BEFORE THE ARKANSAS POLLUTION CONTROL AND ECOLOGY COMMISSION

IN THE MATTER OF AMENDMENTS TO REGULATION NO. 2, REGULATION ESTABLISHING WATER QUALITY STANDARDS FOR SURFACE WATERS OF THE STATE OF ARKANSAS	**)**	**DOCKET NO. 14-007-R**

ARKANSAS DEPARTMENT OF ENVIRONMENTAL QUALITY'S RESPONSIVE SUMMARY FORTHIRD PARTY RULEMAKING TO AMEND REGULATION NO. 2

FIGURE J.1 LA-QUAL SCHEMATIC DIAGRAM

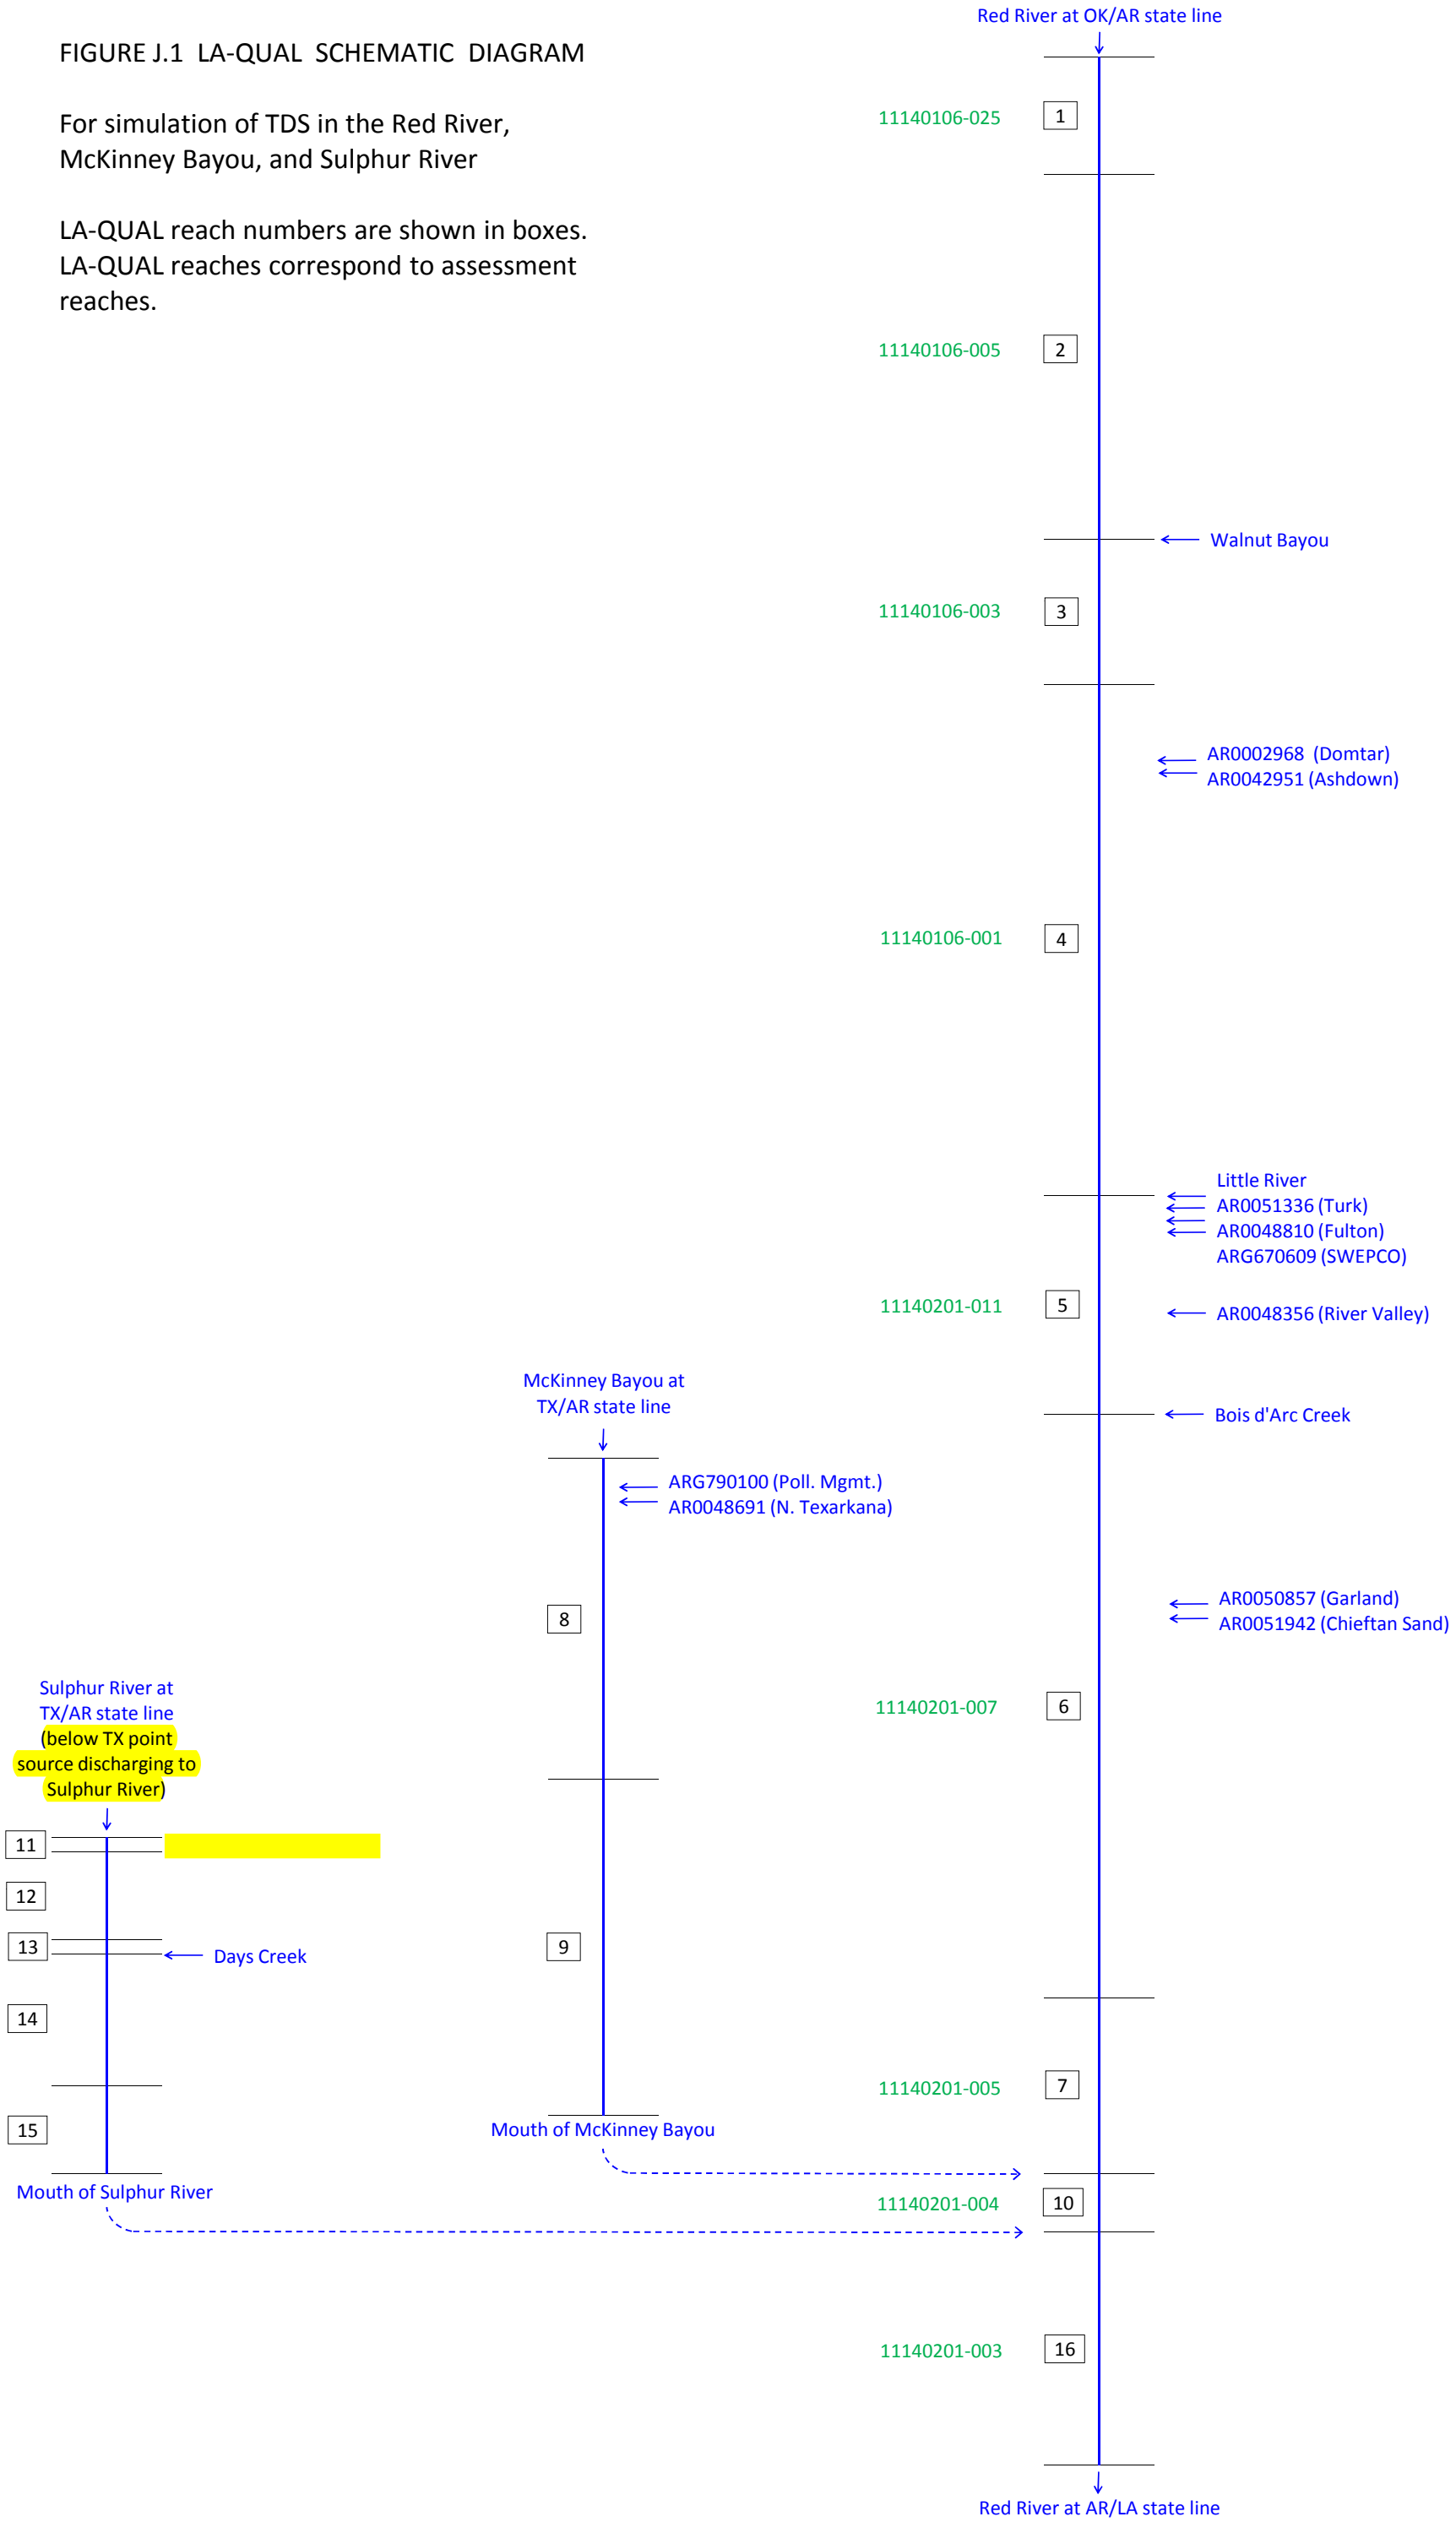
In Figure J.1, IP proposed removing "TX0000167 (Int'l Paper)" from the Sulphur River schematic and beginning the schematic "below TX point source discharging to Sulphur River" thus beginning the model downstream of IP. It is not inaccurate to include IP in the model used to calculate instream water quality criteria; this revision is not necessary.

However, SWEPCO may choose to begin their model at the Arkansas state line or at a point upstream of the state line within Texas for the Sulphur River. In the UAA, as presented, they began their model upstream of the AR state line. If SWEPCO wishes to use an alternate approach and rewrite these portions of the UAA they may do so, however the UAA as submitted is not "inaccurate" as IP states. Regardless of where the model starts, replacing references to International Paper with generic "point source" labels removes transparency and the Department does not support such proposed changes.
